RICHARD L. MEEHAN

**April 17, 2020**

**Re: Dairi Prima Minerals (DPM) Mine site risks and Tailings disposal safety.**

**Summary:** Based on information available, and without a site visit, I provide comment on tailings dam stability risks associated with the Dairi Prima Minerals (DPM) mine in Dairi Regency, North Sumatra.

Figure 2. View of author's estimate of tailings

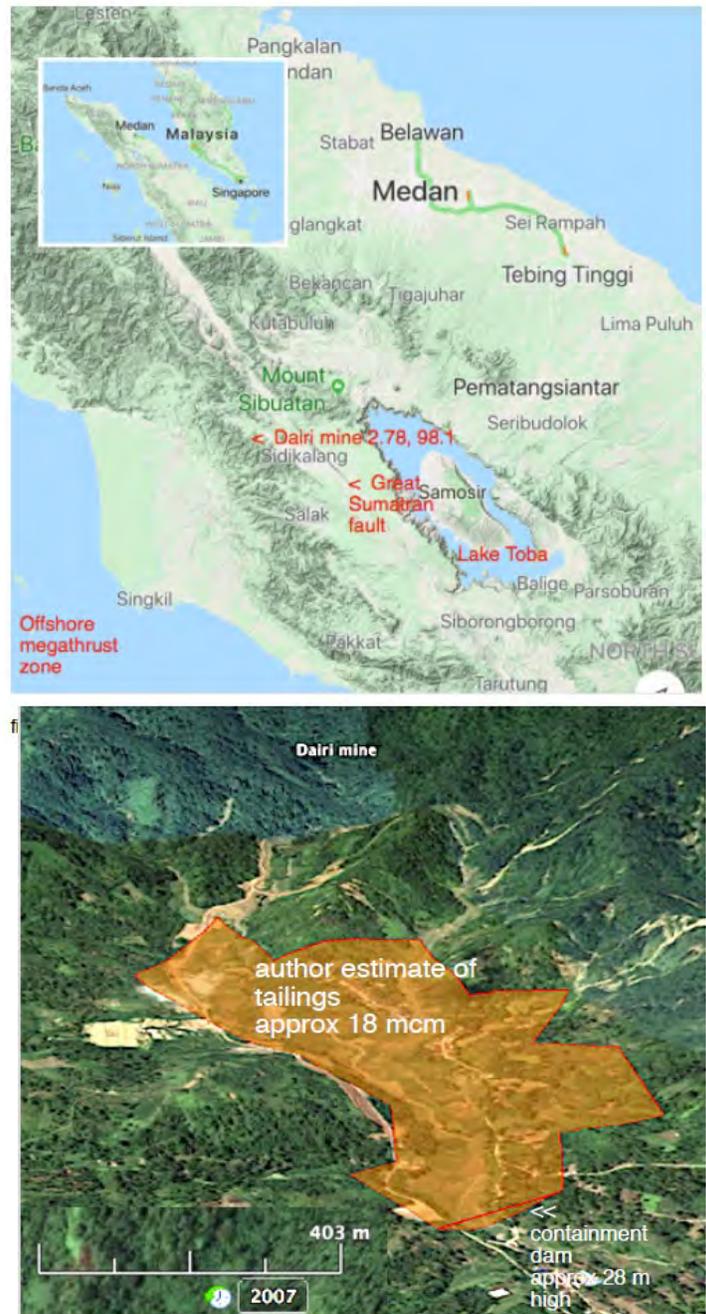
For the current 30 mt plan, I estimate the volume of above-ground storage for the waste slurry would be on the order of 10 mcm. Additional volume would be required to hold stormwater and landslide debris (see below) and whatever freeboard (reserve storage) is required for safety. Altogether my working estimate for full capacity of the storage facility is about 18 mcm. If this is correct, that would require a tailings facility as shown in figure 2. Note that this estimate assumes complete success in the paste backfill plan, which as yet has not been demonstrated in terms of economics (millions of tons of expensive cement will be needed), technical aspects (a successful recipe has not been shown) or safety (the paste backfill could increase the possibility of toxic chemical leakage from the abandoned mine into the environment).

Figure 3. Historical earthquake per

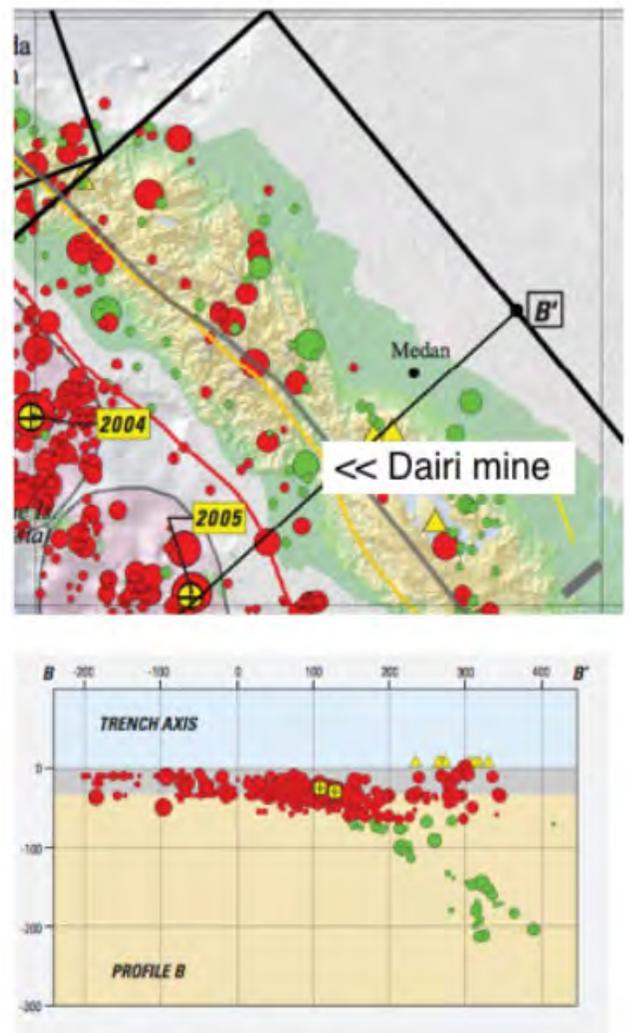
The mine is located in one of the world's most active earthquake regions, along the Sumatra subduction megathrust apparently near a triple plate junction which produced in 2004 and 2005 earthquakes of magnitude 9 and 8+ respectively (fig 3). These events rocked buildings as far away as Bangkok and produced intense regional damage including to road embankments and bridge abutments, which are similar in their behavior to tailings dams. Intensity of ground motion produced destruction of facilities at Banda Aceh, which is a comparable distance from the earthquake to the Dairi mine. Japanese investigators (see Sorenson et al) found that damage was up to about level 6, Japanese JMA scale. This damage category (6.0-6.4) produces these effects:

A map and cross section showing historical earthquakes is extracted from a comprehensive summary of seismicity of the area published by the US Geological Survey (USGS, 2003). This map and many other publications provide comprehensive information on regional seismicity sufficient to evaluate earthquake risk.

figure 5. Tailings dam very close to Sumatra fault with likely earthquakes up to M 7.5-7.9 and ground accelerations of 100%g

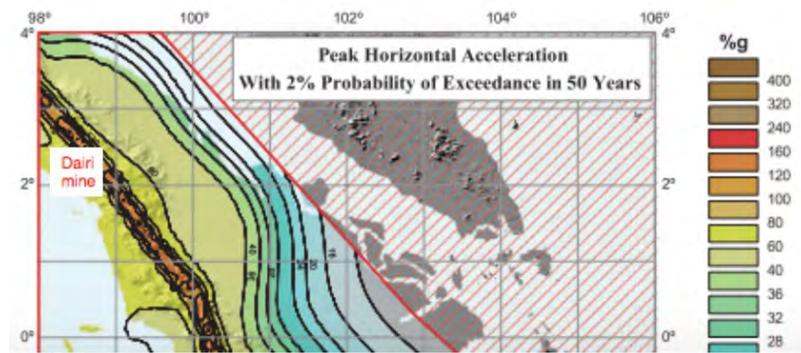
Although the offshore subduction zone mega earthquake poses a threat to long-period structures like tailings deposits, a more dangerous type of earthquake can be expected from the Great Sumatra fault which breaks ground only 15 km to the east of the Dairi site. According to Peterson et al (Ref Peterson) and others this fault is capable of generating earthquakes up to magnitude 7.5 to 7.9 and at this close distance are likely to produce very high ground accelerations on the order of 50-100% gravity (Figure 5).

Earthquakes of magnitude 6 to 7 are routine on and near the Great Sumatran Fault and will certainly occur during the mining phase and cause at least some damage to the facility even under the best of conditions -- a robust dry dam built on a strong rock foundation. If the dam and particularly the foundation fall short of this ideal (most likely) the damage will be severe and may lead to a breach. More likely is a foundation consisting of variable volcanic ash and other deposits discussed above that will not provide sound support for the dam.

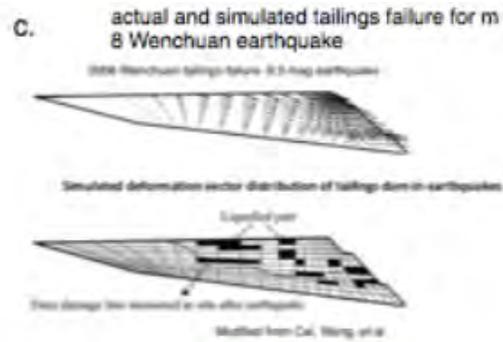
Failure of the containment for wet tailings would be most dangerous in the wet season with an abundance of water added to the containment. Cracking and sliding of the retaining structure would initially take on the appearance of the partial failure of the San Fernando dam, figure 6b (Castro et al 2003). But the San Fernando dam was subjected to only a few seconds of strong shaking. Larger earthquake from m 7.5 to 9 would produce shaking that would be much longer in duration with cracks and sliding of many meters in even robustly built dams. This would open the embankment to through flow of water and wet tailings, which would breach the Dairi containment (as in the Baldwin Hills Reservoir shown on video at <https://www.youtube.com/watch?v=c4sm7DdIMkk>) and also the Brazilian Brumadinho Mine.
